Cobham House Vineyard, Sole Street, Kent, DA12 3AA

REBUTTAL TO OBJECTORS' LANDSCAPE STATEMENT

**LAND AT GOLD STREET, COBHAM DA12 3AA – APPLICATION REF
20240544 - FOR PRIOR APPROVAL UNDER CLASS A PART 6 of SCHEDULE
TOWN & COUNTRY (GENERAL PERMITTED DEVELOPMENT)(ENGLAND)
ORDER ('the GPDO') FOR WINERY BARN**

Rebuttal Notes to Louise Hooper Landscape Statement and Site Options documents
July and August 2024

ZTV for Proposal

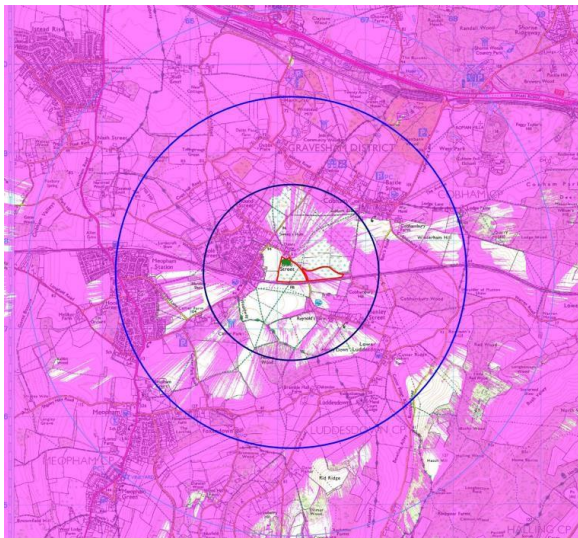
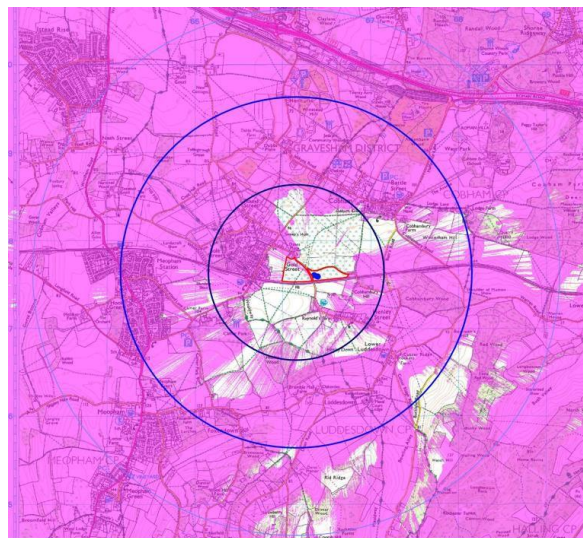
Our view would be that the further Options C and D would in fact be similarly viewed given their more open locations and higher zones of visibility in contrast to the table presented at 2.7 of the LHLA statement which we would argue based upon our own fieldwork, the evidence would not support. To that end we have produced a ZTV for Option D showing how it has increased visibility. We can only assume LHLA measured visual impact by reference to the close neighbours to the site and not wider receptors. LHLA's Table 2.7 is also misleading in giving unsubstantiated evaluation criteria.
